Figure 2.1k
Infrastructure Design Review
- Turbine 11

Bhlaraidh Wind Farm Extension
S36C Varied Development

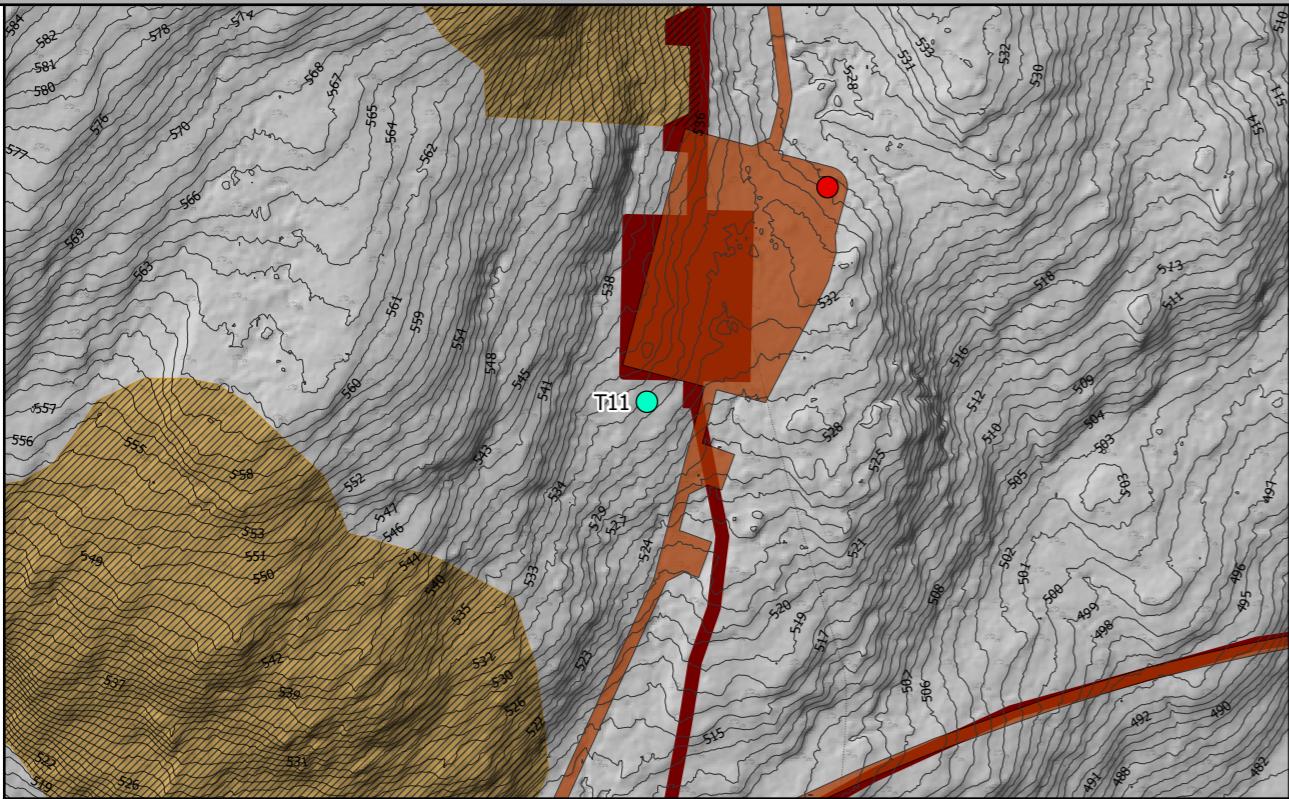
T11: Reason for Moving: This move was necessary because the consented position was too close to the substation platform. The consented position is 1.38 times the tip height of the turbine away from the closest point of the permanent area of the substation platform. To build in safety margins, it is recommended to maintain at least 1.5 times the tip height. It is noted that there is a slight overlap with the north west corner of the substation platform, however suitable distance is maintained to the fencing.

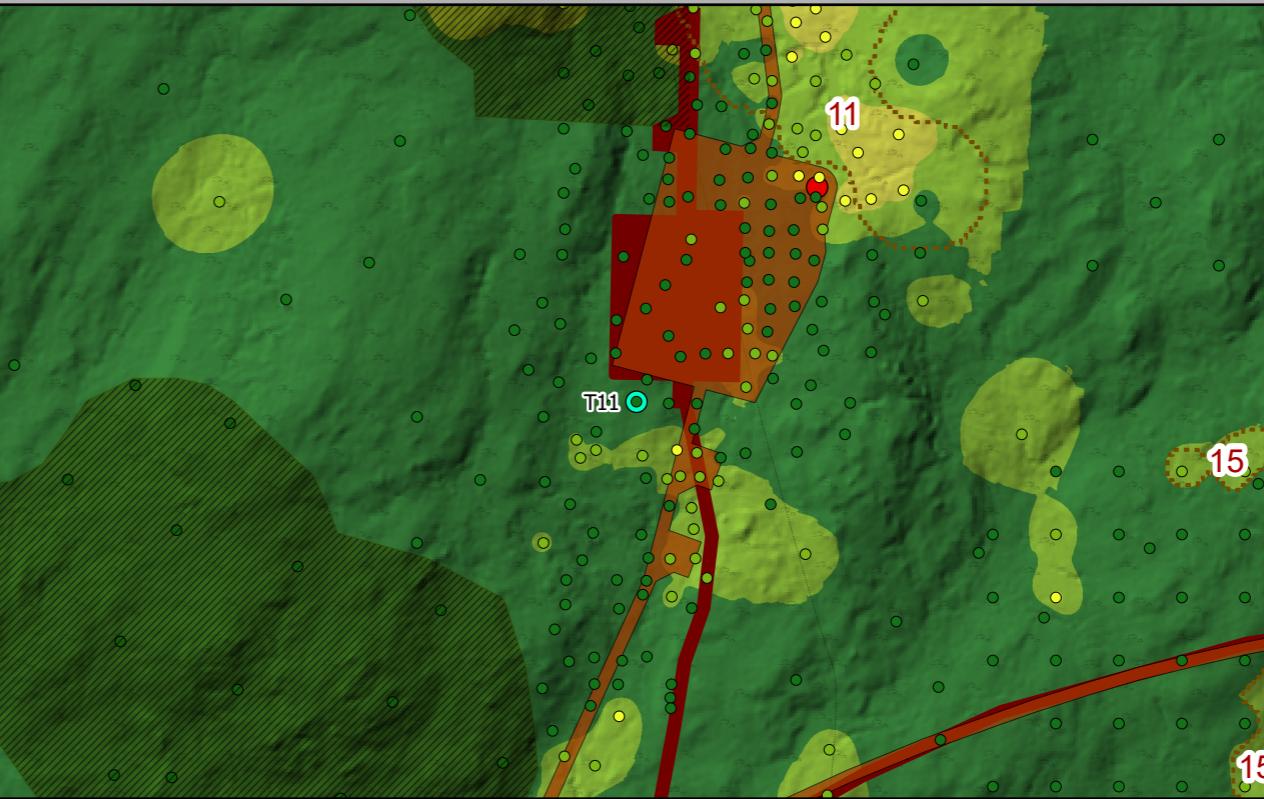
Engineering: The realigned access track leading to T11 meets the main spine at level closer to the proposed hardstand level, allowing for shallower access for component delivery. Also, the orientation of the hardstand is aligned with Vestas 'standard delivery' direction, minimising reverse delivery requirements.

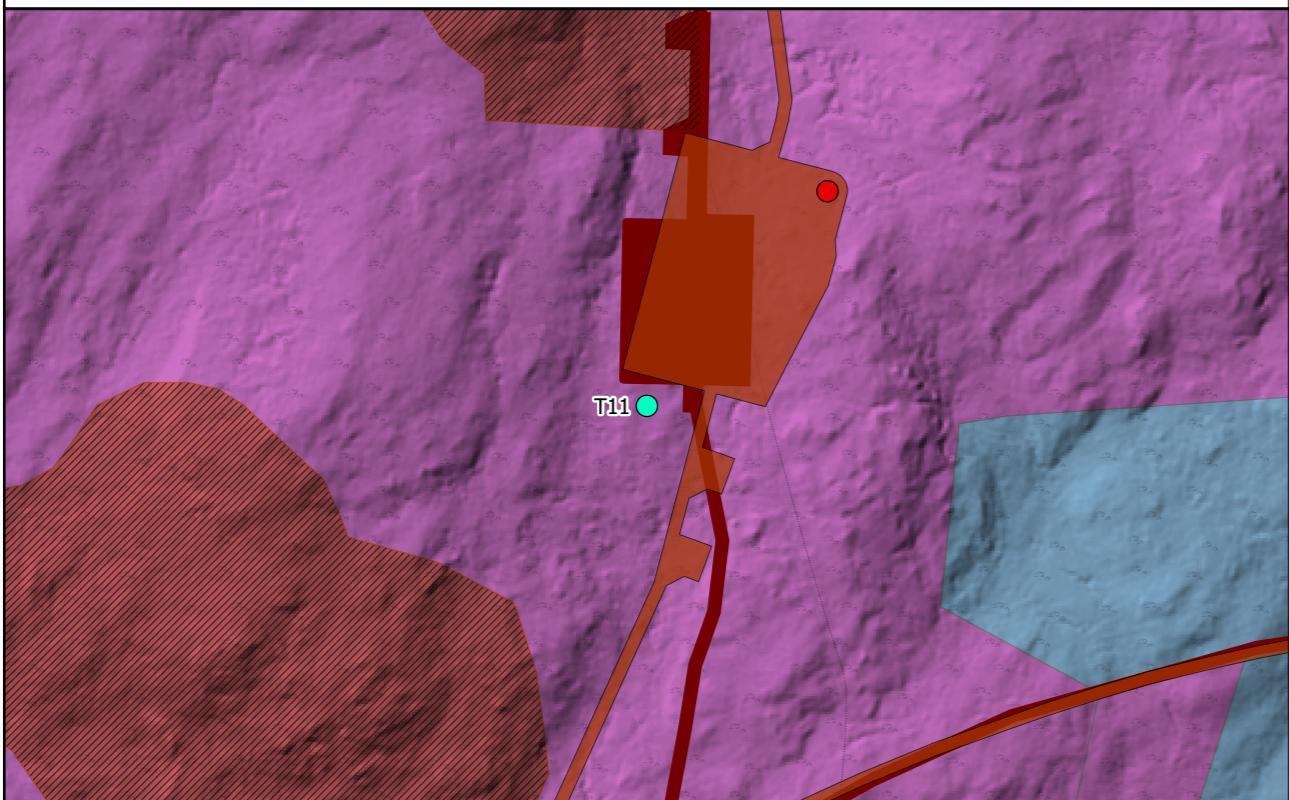
Geology Impacts: Both the consented and proposed infrastructure is located predominantly in shallow peat with small pockets of medium depth peat. The hardstand has been reoriented to maintain the infrastructure in mainly shallow peat. Due to the area of the platform requiring to be flat across the entire length, the track been realigned to accommodate a shallower track up to the start of the hardstand. All proposed infrastructure is located in the consented 50m micrositing buffer.

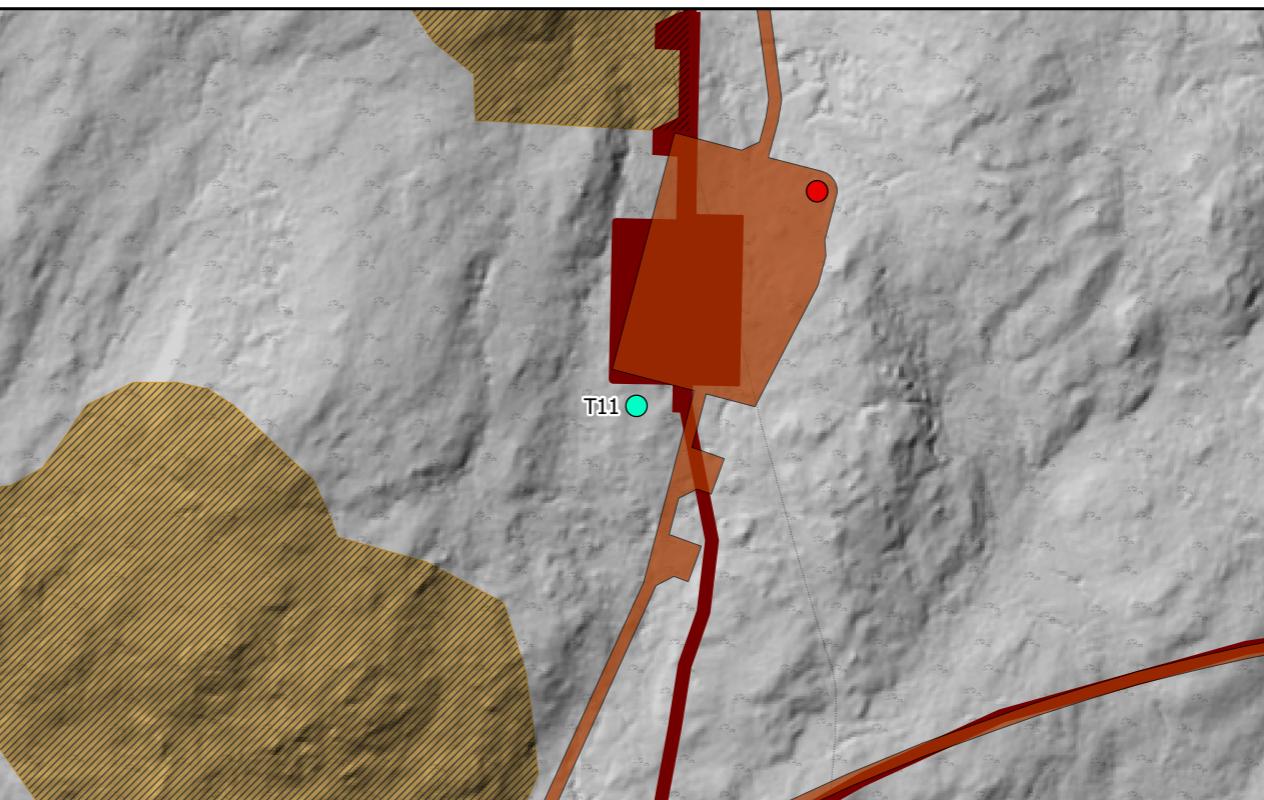
Ecology Impacts: Both the consented and proposed infrastructure sits entirely in Wet Heath (M15c). The proposed layout removes most of the impact of the site track going through a patch of "M11 Yellow Saxifrage" to the north of the hardstand. On balance the proposed track alignment is required to pass across the end of a patch of "M11 Yellow Saxifrage" to the south. The proposed track alignment to the north passes through a section of "HMO Peat Restoration Area".

Hydrology Impacts: The proposed location is outside the 50m water buffers.
